## Updated Description of Phased Build Alternative from Final EIR, Appendix 5 Alternatives Screening Report

The changes shown in this section with underlining and ~~strikeout~~ show changes made after publication of the Final EIR was published in December 2015.

West of Devers Upgrade Project

**Updated Description of  
Phased Build Alternative (February 2016)**

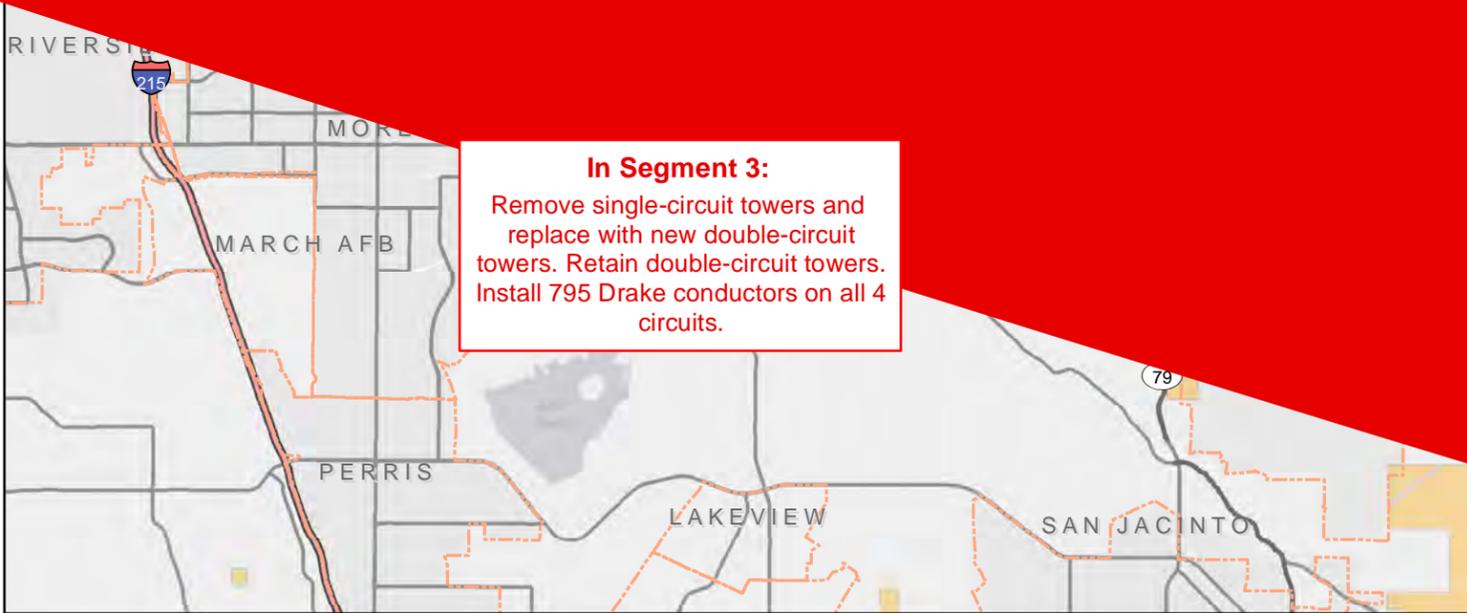
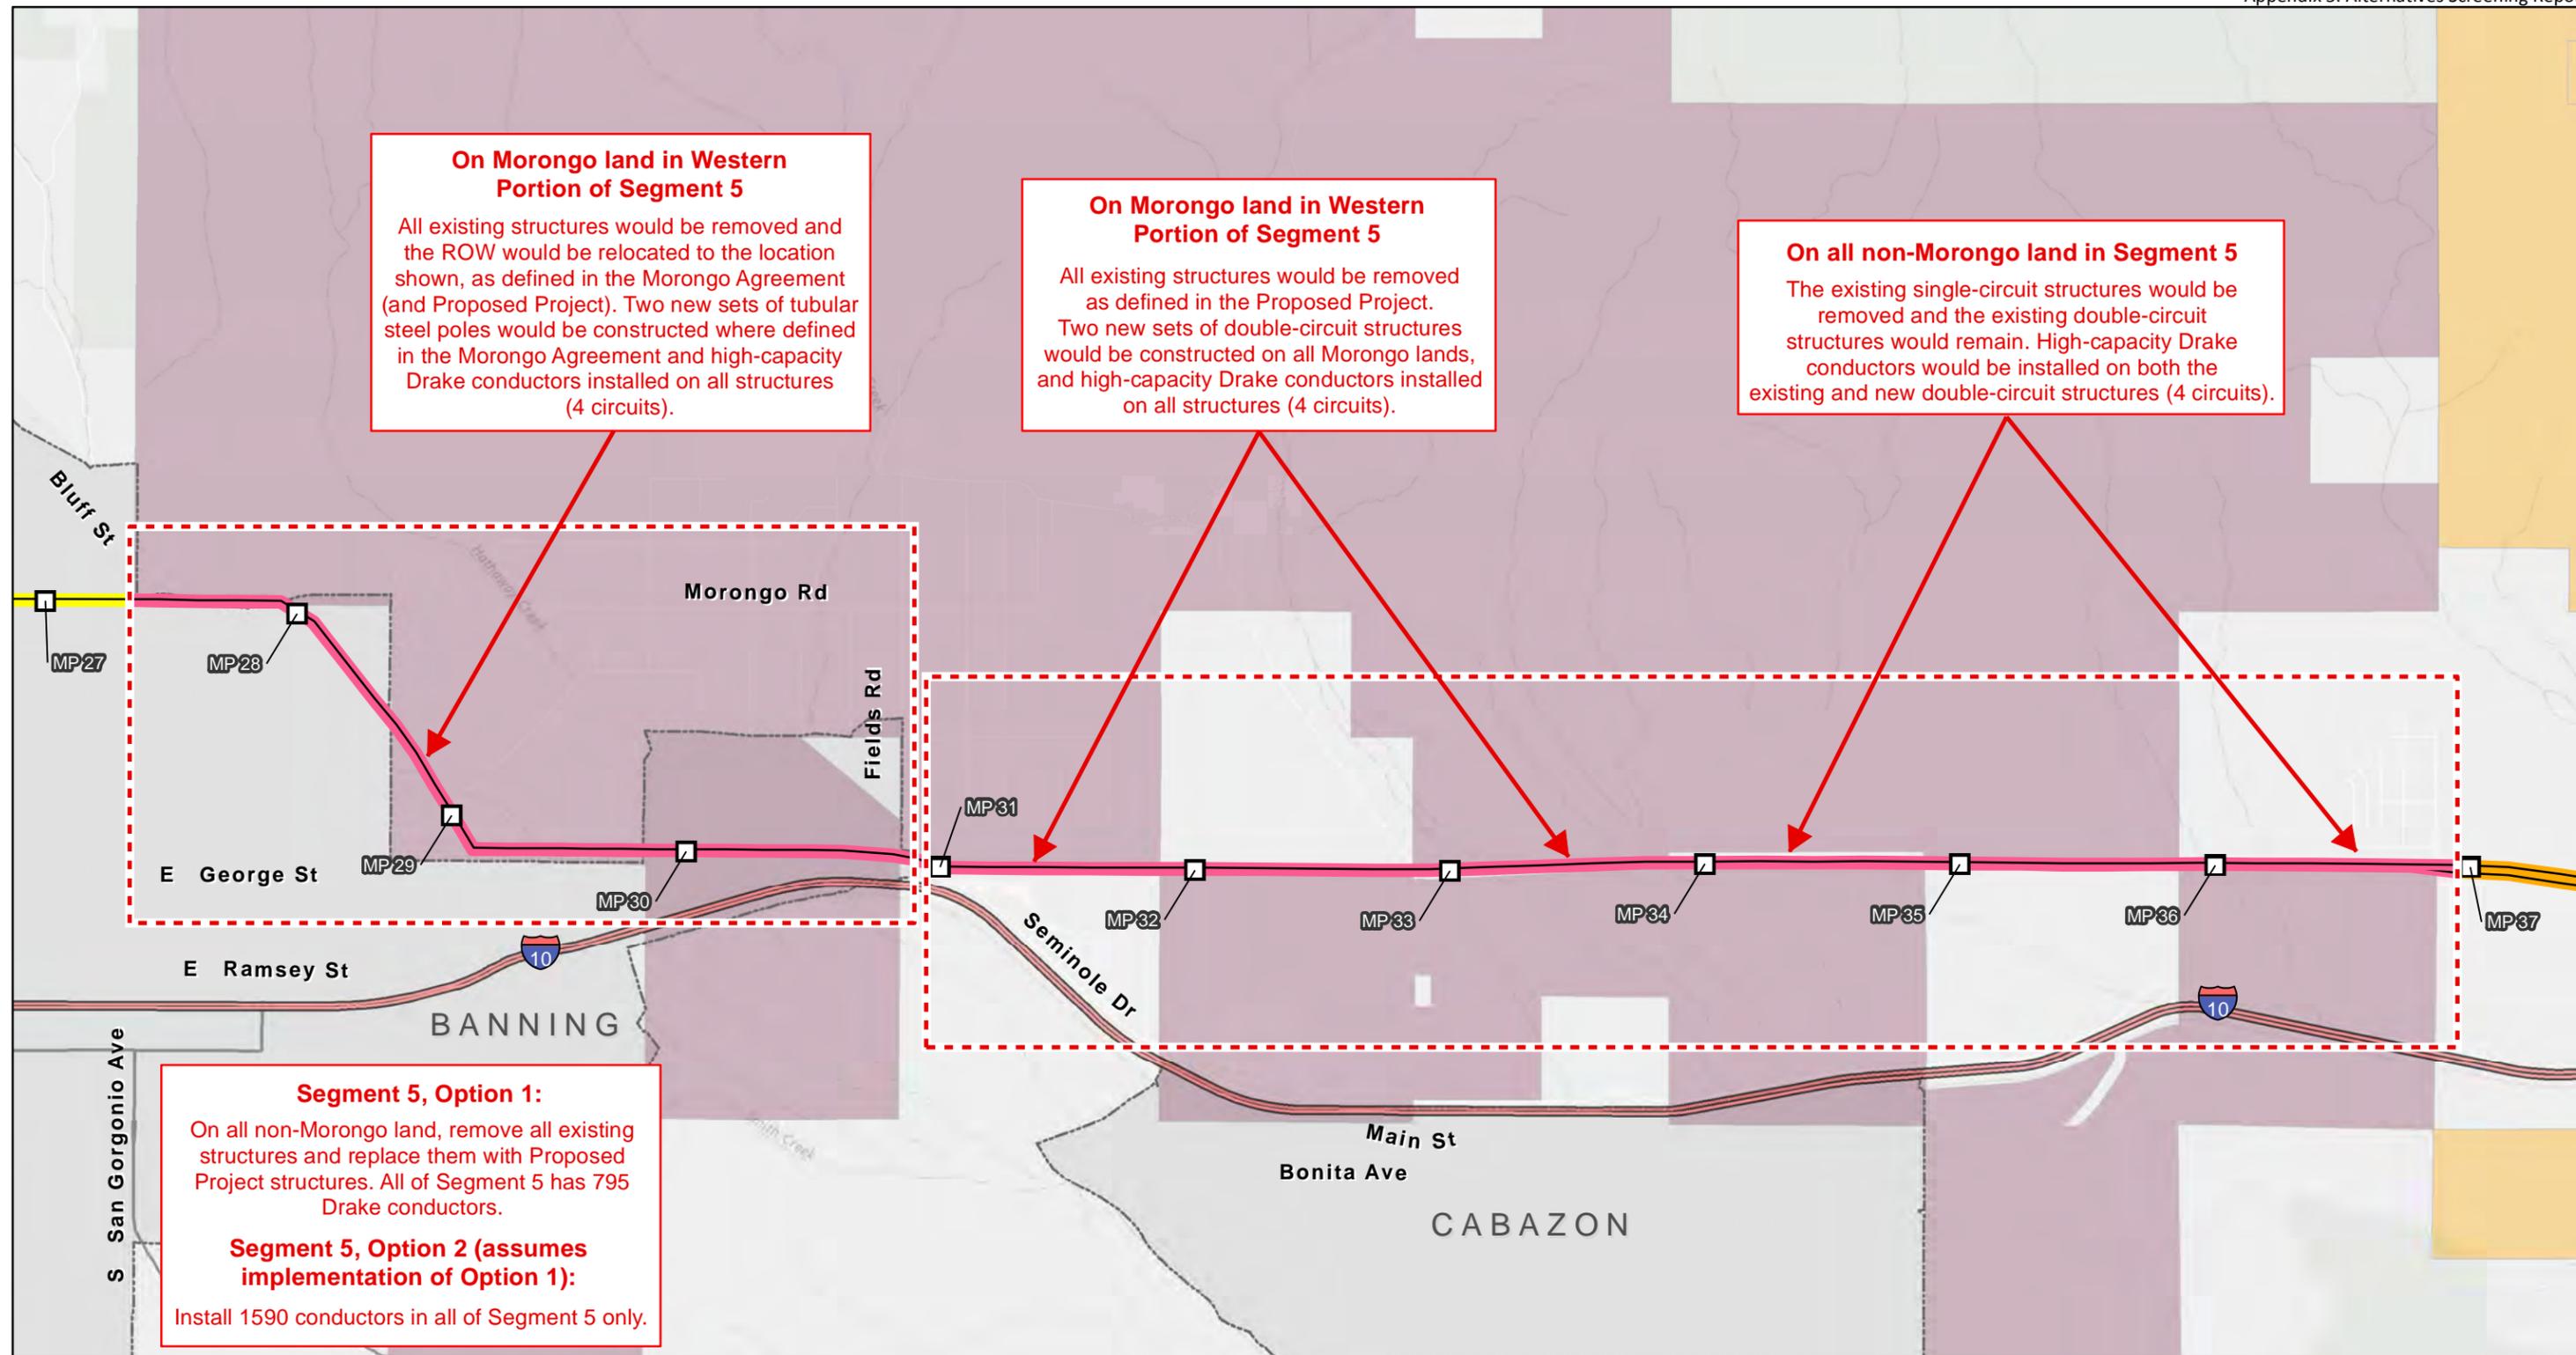
**In Segment 1:**  
Re-use existing double-circuit towers and install new 795 Drake conductors.

**In Segment 4:**  
Remove single-circuit towers and replace with new double-circuit towers. Retain double-circuit towers. Install 795 Drake conductors on all

**On all Morongo land in Segment 5:**  
All existing structures would be removed and the structures in the Proposed Project would be installed. Tubular steel poles (at western end) and lattice steel towers (remainder of Morongo lands) would be constructed, as defined in the Morongo-SCE Agreement.

**In Segment 2:**  
Re-use 4 circuits existing double-circuit towers and install new 795 Drake conductors.

**In Segment 3:**  
Remove single-circuit towers and replace with new double-circuit towers. Retain double-circuit towers. Install 795 Drake conductors on all 4 circuits.

**On all non-Morongoland in Segment 5:**  
The existing single-circuit structures would be removed and existing double-circuit structures would remain. High-capacity Drake conductors would be installed on both the existing and new double-circuit structures (4 circuits).

**In Segment 6:**  
Remove single-circuit towers and replace with new double-circuit towers. Retain double-circuit towers. Install 795 Drake conductors on all 4 circuits.
